**Gunthar's Run Subdivision Homeowners  
Requesting Denial of Final Preliminary Plat Recommendation  
For City File No. 04-011 – Grace Parc**

July 16, 2013

Rochester Hills Planning Commission  
Mr. William Boswell, Chairperson  
1000 Rochester Hills Dr  
Rochester Hills, MI 48309

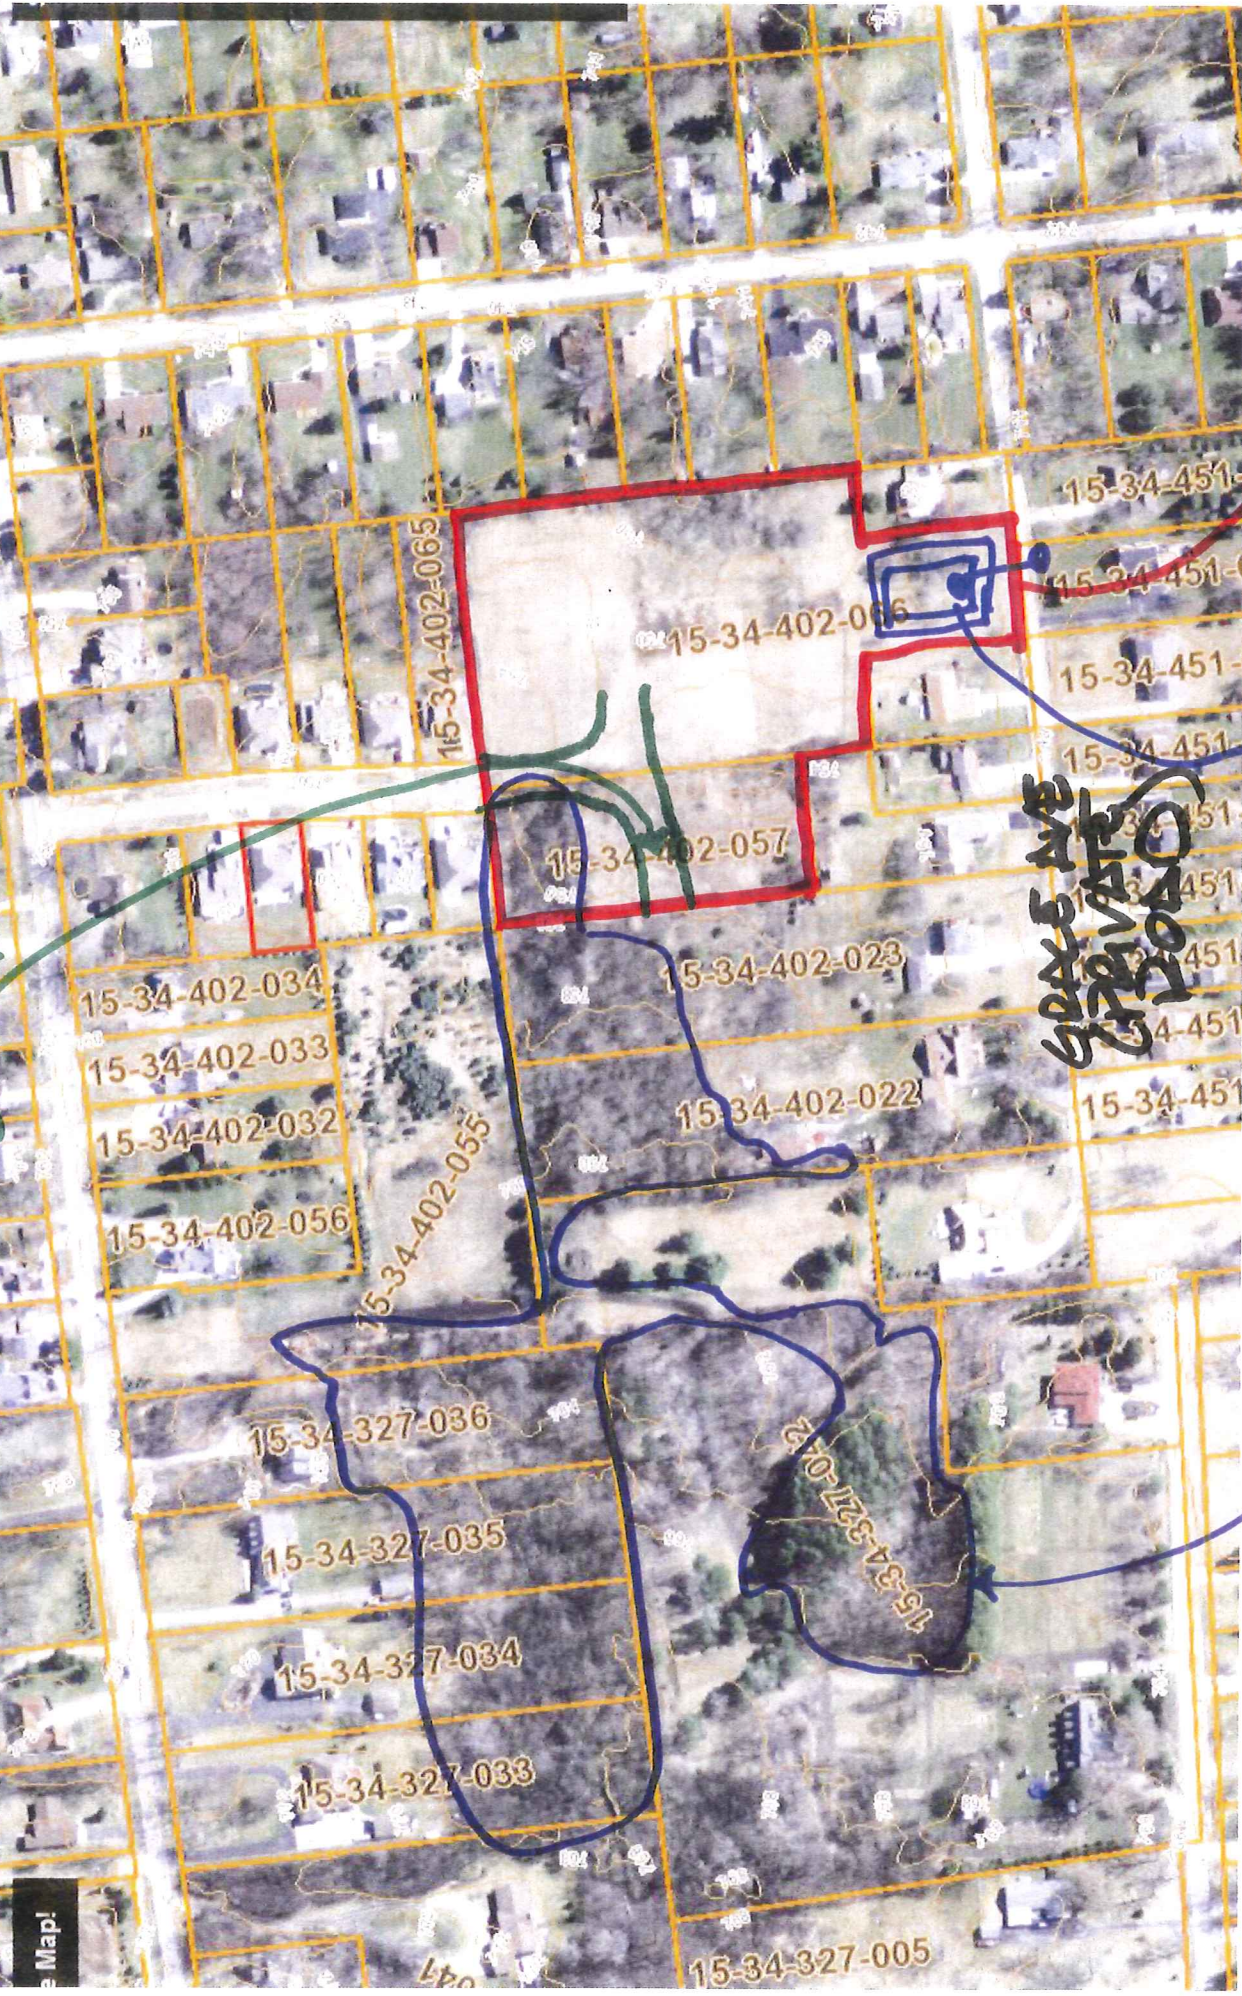
Additionally, as illustrated on the accompanying diagram and poster, the additional parcels in question in appear to include a substantial amount of regulated wetlands that would require separate expensive and difficult-to-obtain State approvals, in addition to City approval, while adding very little, if any land for additional houses beyond the initial fourteen.

APPROX. LOCATION OF STIONS  
ROAD HOW WILL 2nd FT OF ACCESS EVER BE ACHIEVED

DETACHMENT  
BASIN OUTLETTING  
TO FLEWATE ROAD  
OFF 151 ROAD V. INK

REQUESTED  
WETLANDS?
